Cosumnes River Bridge Replacement Project

Initial Study with Negative Declaration/Section 4(f) De Minimis Determination

Prepared by the
State of California, Department of Transportation

May 2019

Figure 1. Project Location Map – Cosumnes River Bridge Replacement Project

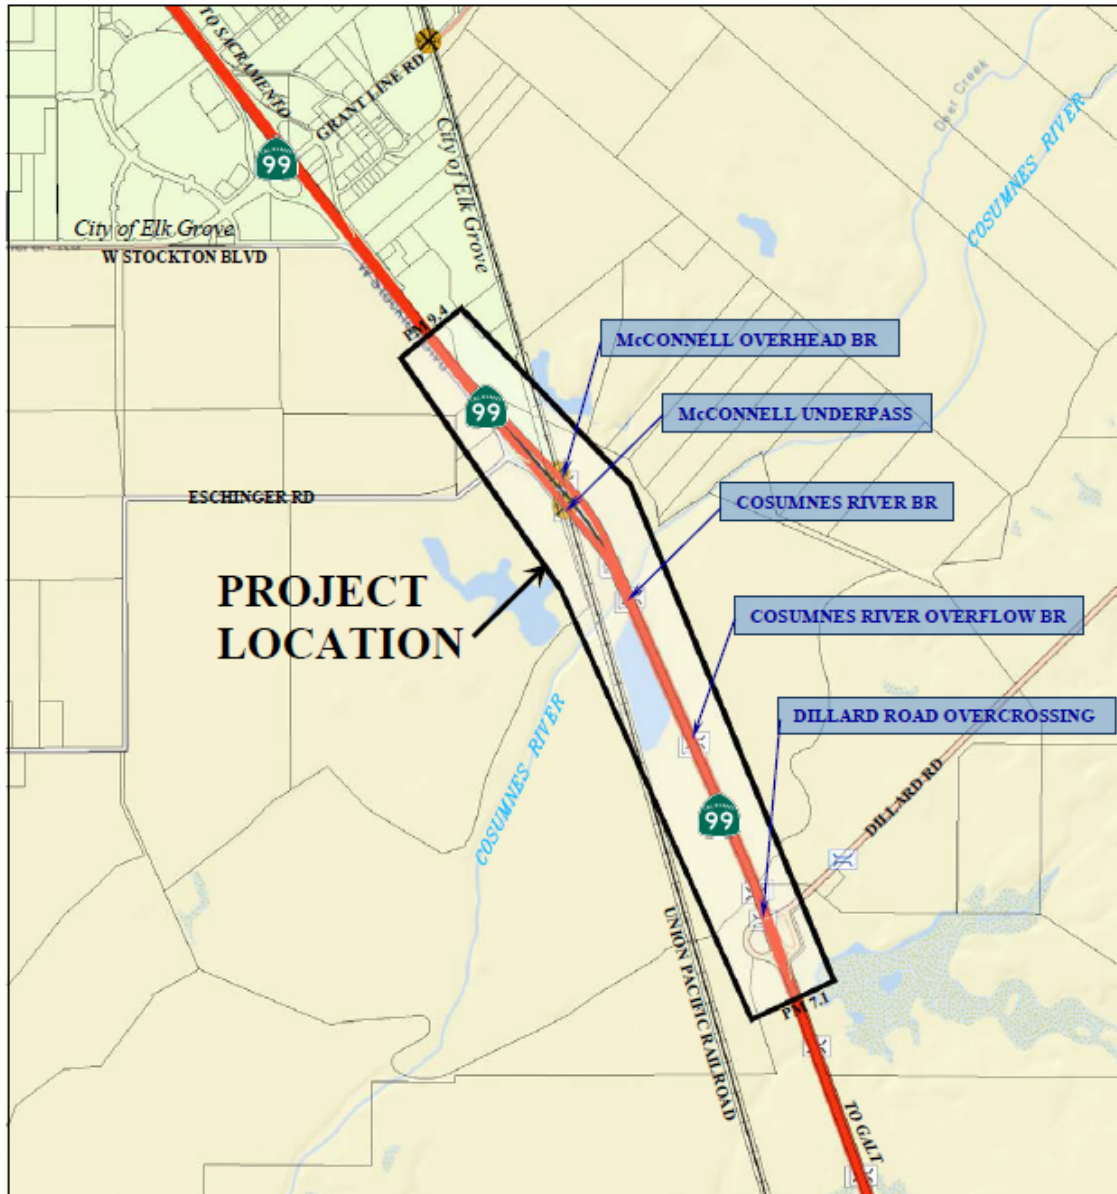
- 29 • It is unclear why there are two different "ESL Boundary Line" on Figure 2, please explain.
- 30 • Figure 2 is difficult for reader to orient where each map page is on the Project. Provide a grid index/over view map showing where each detailed map occurs throughout the Project.

Figure 1 is an overview map of the project, with key project features identified. The individual ESL maps show the project in segments from the southern boundary at PM 7.1 to the northern boundary at PM 9.4. Nevertheless, Figure 1 has been revised to include a grid index/overlay and the Figure 2 ESL maps have been labeled accordingly. See Appendix B.

Figure 2. Environmental Study Limit (ESL) Mapping

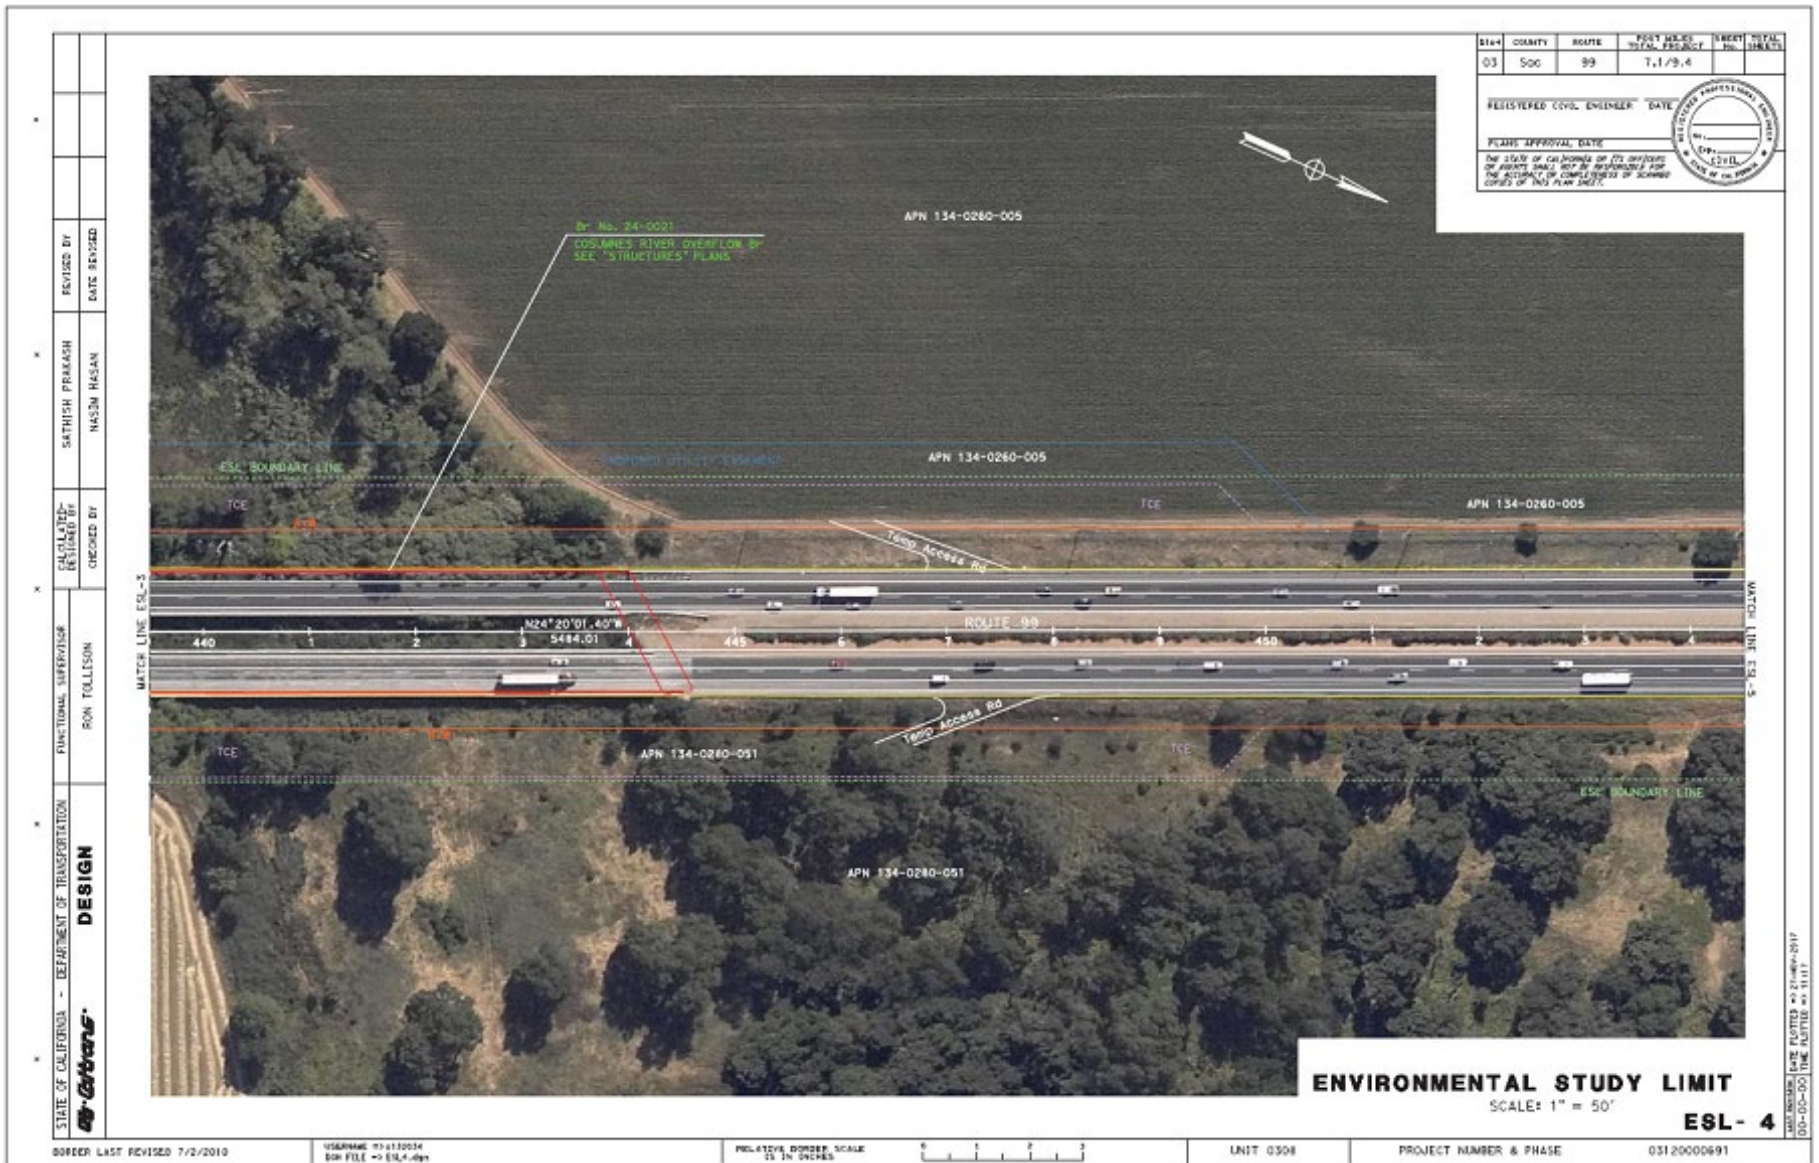
- 27 • Document and supporting technical studies reference post miles. These post miles should be depicted on maps within the document.
- 28 • It is unclear if every supporting technical study utilized the same study area delineated as the "ESL Boundary Line" on Figure 2. Please clarify.

All technical studies utilized, at a minimum, the ESL boundary line shown on Figure 2. Certain components of the technical studies (e.g., nesting bird surveys) utilized a greater area due to the protocol requirements of the surveys.

Figure 2 identifies the ESL boundary as both the Wood Rodgers ESL Boundary Line (green dashed line) and Additional Caltrans Work ESL Boundary Line (yellow dashed). These lines are not in conflict and comprise the ESL boundary.
